Company	Trenz Electronic GmbH
PCN Number	PCN-20240615
Title	TE0818-02 DCDC (U19/U37) Stability and power consumption improvement
Subject	DCDC (U19/U37) Stability and power consumption improvement
Issue Date	2024-08-14

2.1 #1 Changed resistor (R119) from 33.2 kOhm to 15 kOhm.

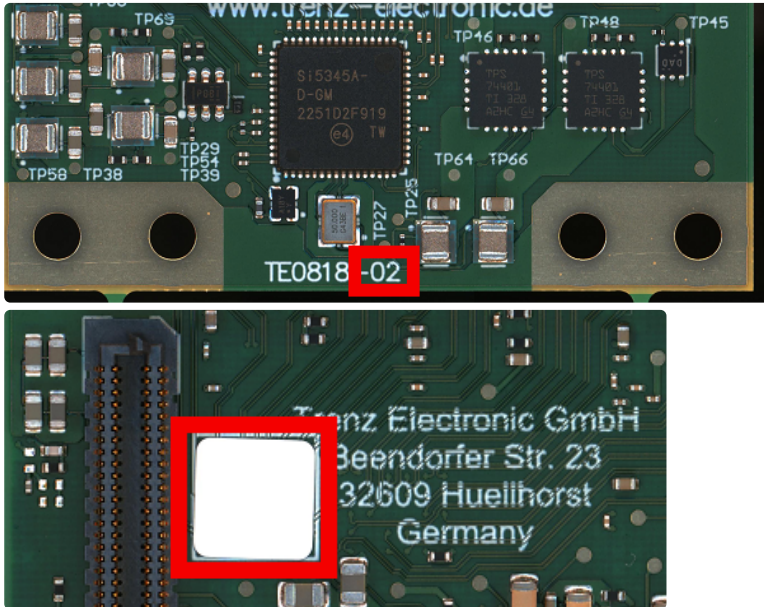
Type: BOM Change

Reason: Optimize DCDC (U19/U37) compensation network.

Impact: Improved stability and power consumption.
